CONTAINER

Notice of Allowability For A Design Application

REPLY TO OFFICE ACTION AND AMENDMENT UNDER 37 CFR § 1.111

DETAILED ACTION

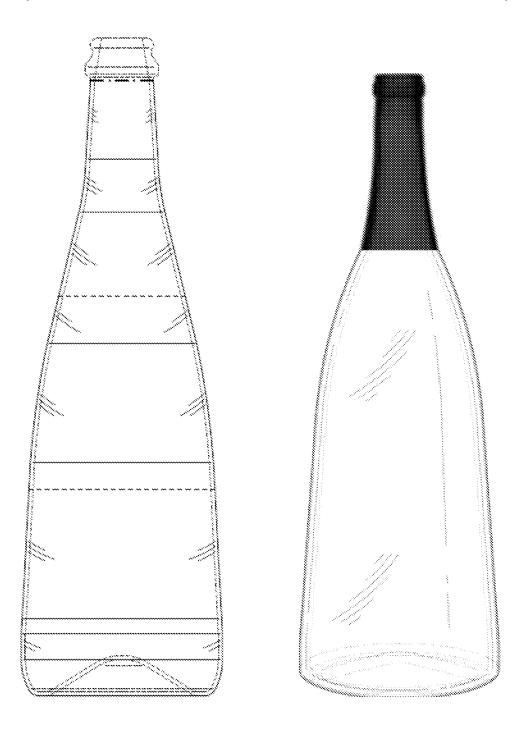
Below left, Waterloo is presented in a side-by-side comparison with Lauret, shown below right, wherein the Waterloo and Lauret are sized for a common body diameter.

It is difficult to imagine why an artisan would wholesale replace claimed features and proportions of Waterloo with features and proportions of Lauret unless, of course, the artisan already had the benefit of hindsight through the looking glass of Applicant's own claimed design. Each applied reference teaches a base, body, and shoulder of principally different shape from the other. Therefore, it is difficult to imagine why one of ordinary skill in the art – without knowledge of Applicant's claimed design – would seek to combine two very different base, body, and shoulder contours of principal shapes that are plainly disparate from one another. Thus, the principal shapes of the primary and secondary references are so divergent from one another that the references facially teach away from their combination. Moreover, replacing the tall straight tapered body of Waterloo with Lauret's tapered body would impermissibly destroy fundamental design characteristics of Waterloo's design, such that one of ordinary skill in the art would not seek to do it absent hindsight.

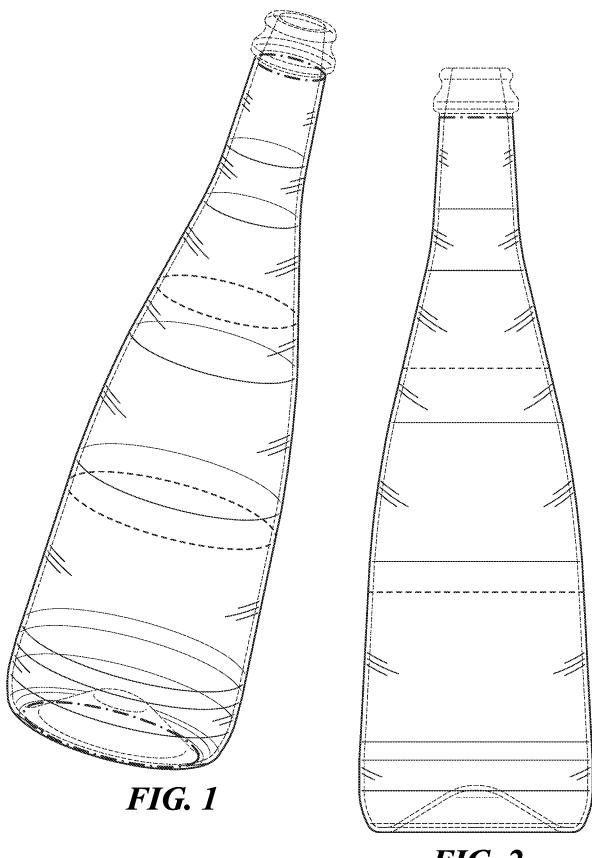
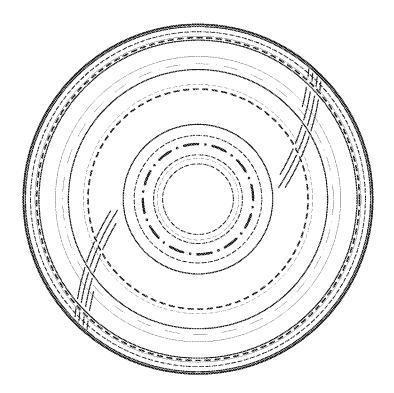
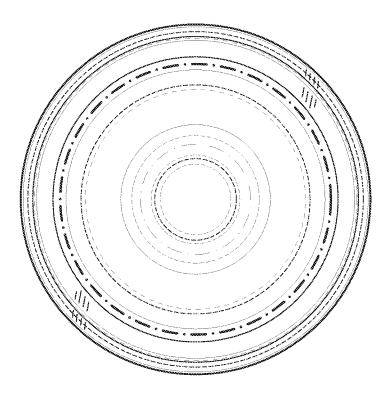
Applicant has addressed the inconsistency between FIGS. 3-4. In addition, in FIGS. 1-4, previously unclaimed subject matter has been converted to claimed subject matter.

The attached replacement sheets of drawings include FIGS. 1-4. These sheets, which

include replacement FIGS. 1-4, replace the previously presented sheets including FIGS. 1-4.

In FIGS. 1-4, previously unclaimed subject matter has been converted to claimed subject

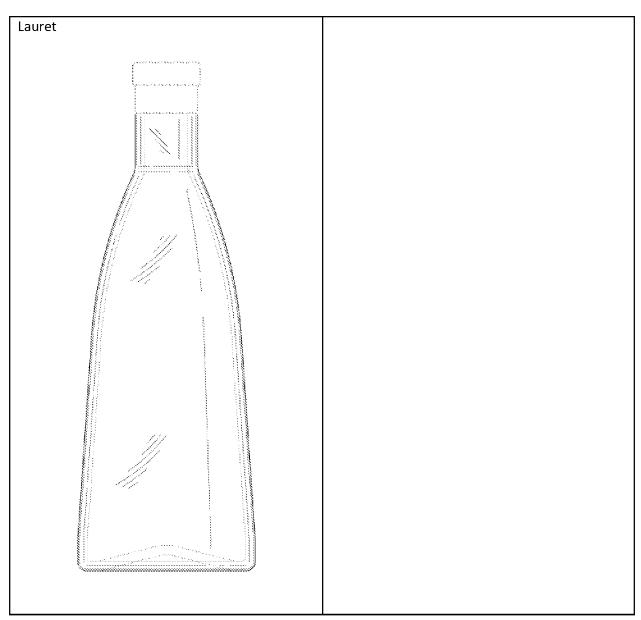
The claim is rejected under 35 U.S.C. 103 as being unpatentable over https://www.amazon.com/12-750-Cobalt-Bottles-Creations-Swanson/dp/B018WM419S/ "750mL Cobalt Blue Stretch Hock Wine Bottles - Case of 12" published by Waterloo Container on August 24, 2016 (hereinafter Waterloo Container) in view of US Design Patent D642,469 S to Lauret (hereinafter Lauret).

Waterloo Container teaches a bottle having an overall appearance with design characteristics that are visually similar to those of the claimed design, in showing a bottle with a tall, slender body and a narrow neck that gradually slopes into the body.

The claimed design differs from Waterloo Container by incorporating a bottle that tapers outward towards the base.

It would have been obvious to a designer of ordinary skill in the art before the effective filing date of the claimed invention to modify Waterloo Container by Lauret by substituting the tapered base of Lauret on the bottle of Waterloo Container because such a modification is no more than a simple substitution of one known design element (tapered base) for another (straight base). Moreover, substitution of one known design element for another known design element in the same field would have been within the skill of an ordinarily skilled designer.

First and foremost, Applicant's amended claimed design is significantly shorter and squatter than Waterloo's comparatively taller and slenderer design.

Second, Applicant's amended claimed design has a short large radiused insweep, which is different from Waterloo's short tightly radiused insweep.

Third, Applicant's amended claimed design has a compound angled body including a short cylindrical lower portion extending away from the insweep and a tall straight tapered upper portion extending away from the lower portion, in contrast to Waterloo's straight cylindrical body.

Fourth, Applicant's claimed shoulder is significantly shorter than Waterloo's shoulder.

Fifth, Applicant' amended claimed neck straight tapered whereas the Waterloo neck is straight cylindrical.
